# TECH NOTE

# HONDA ACCORD/LEGEND/MDX TIMING COVER MODIFICATION REQUIRED WITH REPLACEMENT OF BELT TENSIONER

**BULLETIN:** TSB005\_AU

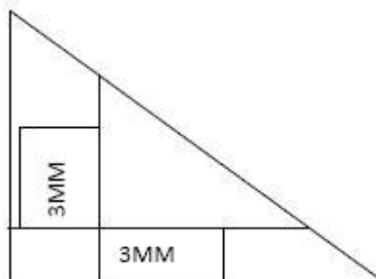
Honda OE now provides an updated tensioner assembly which may cause interference with the front timing cover for some applications. Gates also offers the same updated design as the OE. The update requires that you now remove approximately 3mm of plastic material from the front cover, allowing proper clearance.

THIS AREA WILL NEED TO HAVE 3MM OF MATERIAL REMOVED

The removal of approximately 3mm of plastic material from the lower timing belt cover is recommended prior to the installation of the updated accessory belt drive tensioner, allowing for proper clearance.
